**CITY OF NOVI CITY COUNCIL**  
**MARCH 23, 2026**

**SUBJECT:** Consideration for tentative approval requested by Avalon Investment Group, LLC, for Camelot Parc Townhomes, a 22-unit for-sale townhome development.

**SUBMITTING DEPARTMENT:** Community Development Department - Planning

AVALON PARK DEVELOPMENT, LLC  
 CAMELOT PARC TOWNHOMES  
 PLSR OVERLAY CONCEPT PLAN  
 CAMELOT PARC SHARED MAINTENANCE PLANS

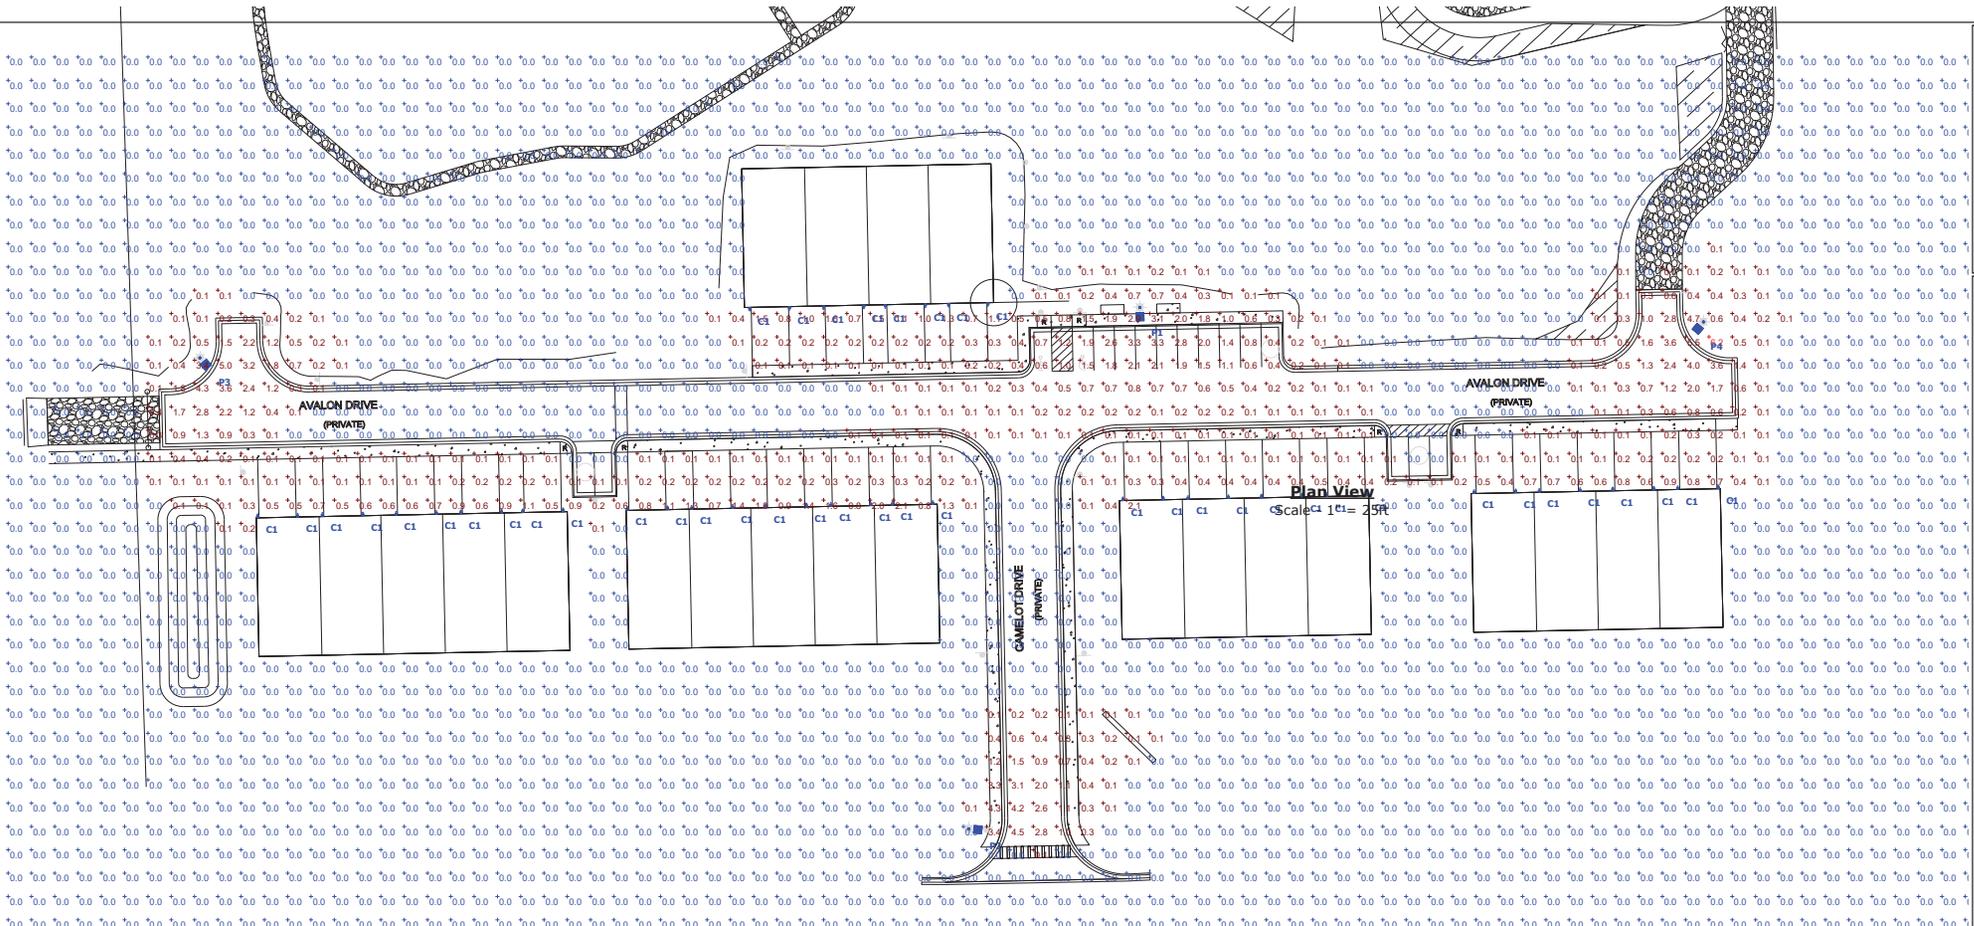
6. **Stonebrook Drive:** The applicant has included a proposed Road Maintenance Plan on Sheet 12 for Stonebrook Drive. The plan calculates a contribution for the proposed Camelot Parc toward Stonebrook Drive maintenance costs based on the length of the road, percentage of road used to access Wildlife Woods Park, and the total number of units for each development. **As Stonebrook Drive is a private road owned by Villas at Stonebrook HOA, the applicant has indicated they are discussing the road maintenance agreement with them. Any cost-sharing agreement would be a private agreement between the two entities.**

3. *The applicant has included a proposed Road Maintenance Plan on Sheet 11 for Stonebrook Drive. The plan calculates a contribution for the proposed Camelot Parc toward Stonebrook Drive maintenance costs based on the length of the road, percentage of road used to access Camelot Drive, and the total number of units for each development. As Stonebrook Drive is a private road owned by Villas at Stonebrook HOA, the applicant should meet with them to discuss proposed*

- Increased contribution to 25% by Camelot Parc toward shared area expenses
- Now includes entire length of Stonebrook Drive
- Added contributions toward lawn care, sidewalks and irrigation in addition to the roadway along the Stonebrook Drive corridor

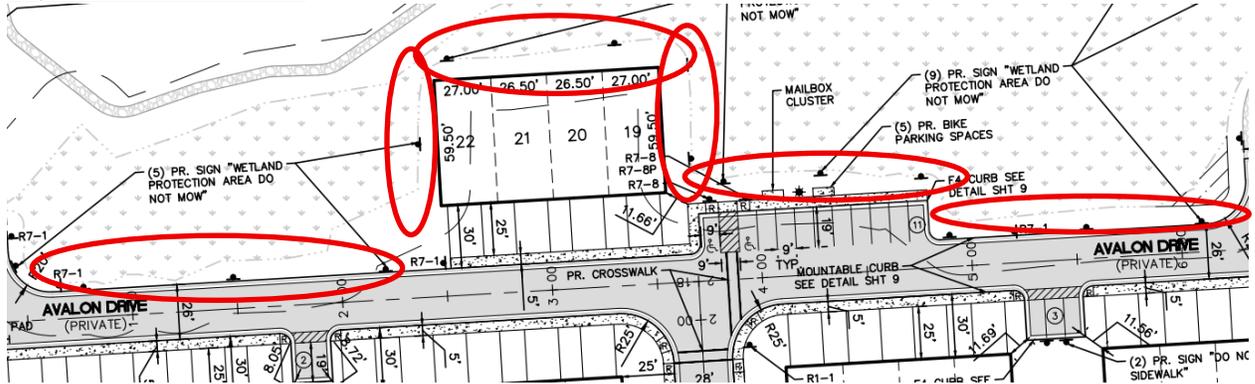
**Requested edit:** In future submittals, buffer impacts should be differentiated by permanent and temporary impacts (if applicable). If impacts are temporary, descriptions or sequencing should be provided showing how the temporary impacts will be restored. The temporary wetland restoration sequencing provided on Sheet 7 can be applied to any temporary buffer impacts – the header will need to be updated. Identify any temporary buffer impacts using a different symbology in the site plan.

Requested Placement locations

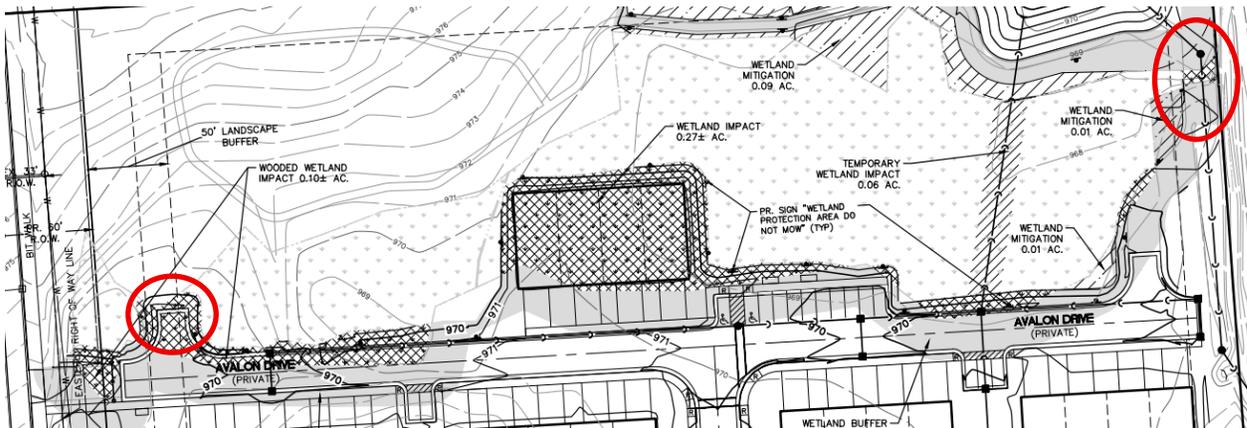
**The italicized text and image below are originally from Comment 5 in the July 2025 wetland review and has been addressed in the rrPSLR submittal on Page L-1.**

*Due to the extensive proposed loss of wetland buffer along the southern remaining wetland area, it is requested that the applicant perform environmental enhancement along the southern portion of the remaining wetland (see screenshot below). The applicant should plant at least three different species of wetland rated shrubs throughout the southern boundary of the wetland. This will allow a small separation from the wetland and the proposed development. Additionally, it will deter any accidental mowing of the wetlands and remaining buffer areas. Shrubs could include three of the following species:*

**Attachment A  
Site Photographs**

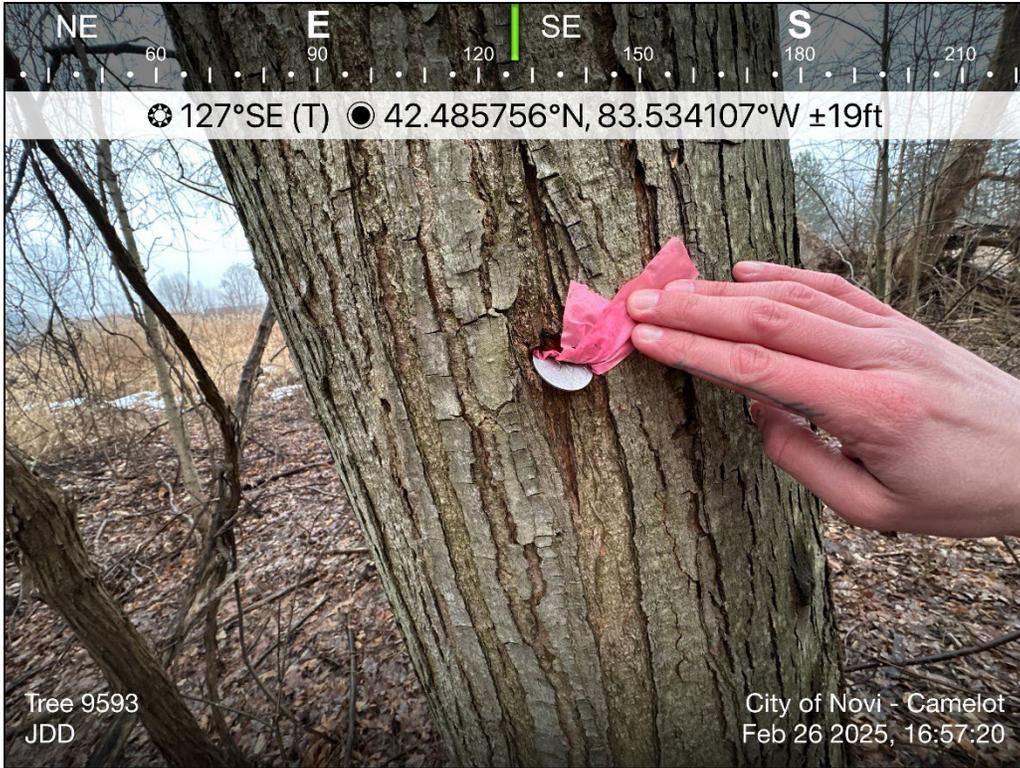
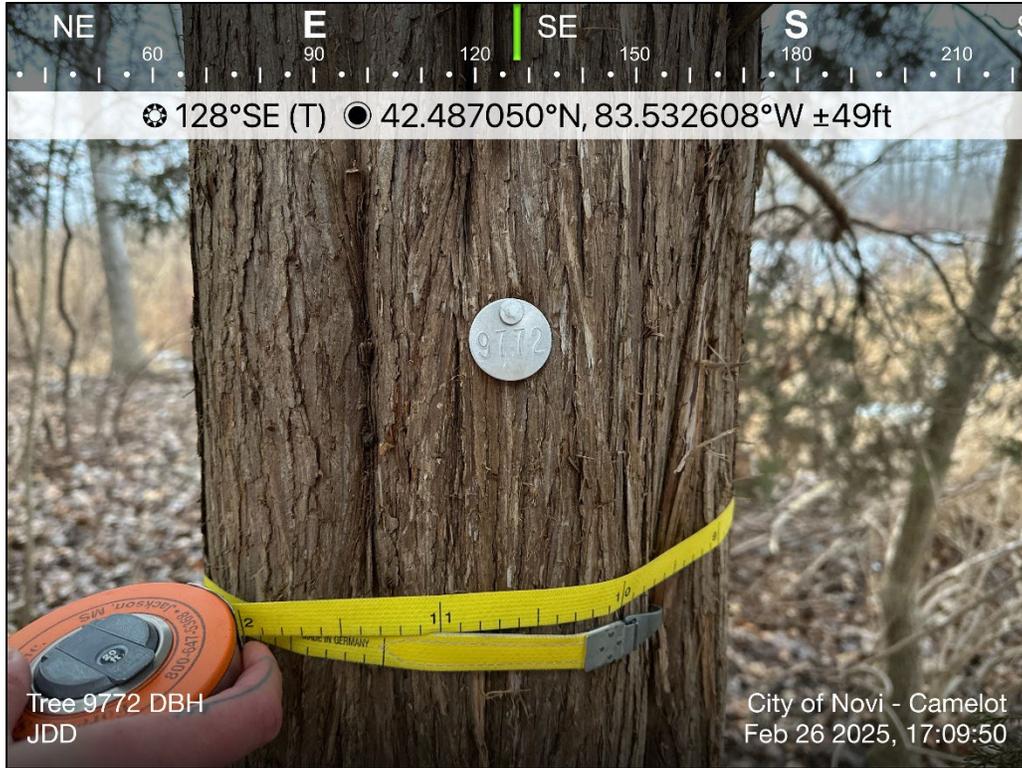
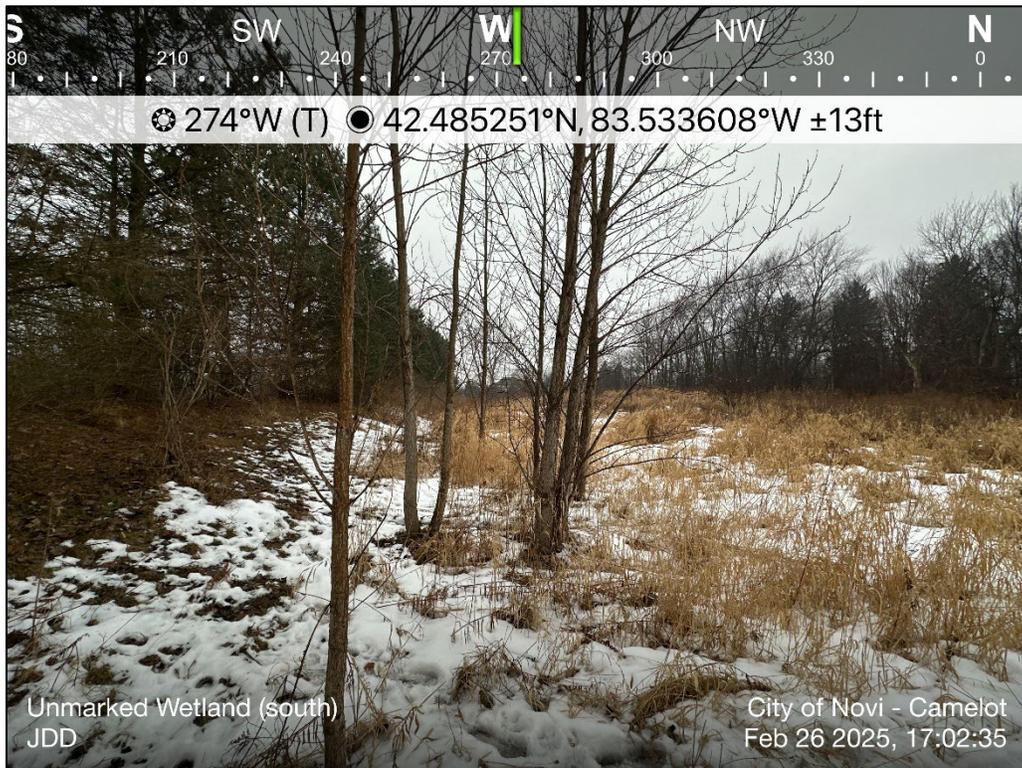
Tree 9593 DBH just under 20inches

DBH of Tree 9596 just over 15 inches

Tree 9772 with a DBH just over 11 inches
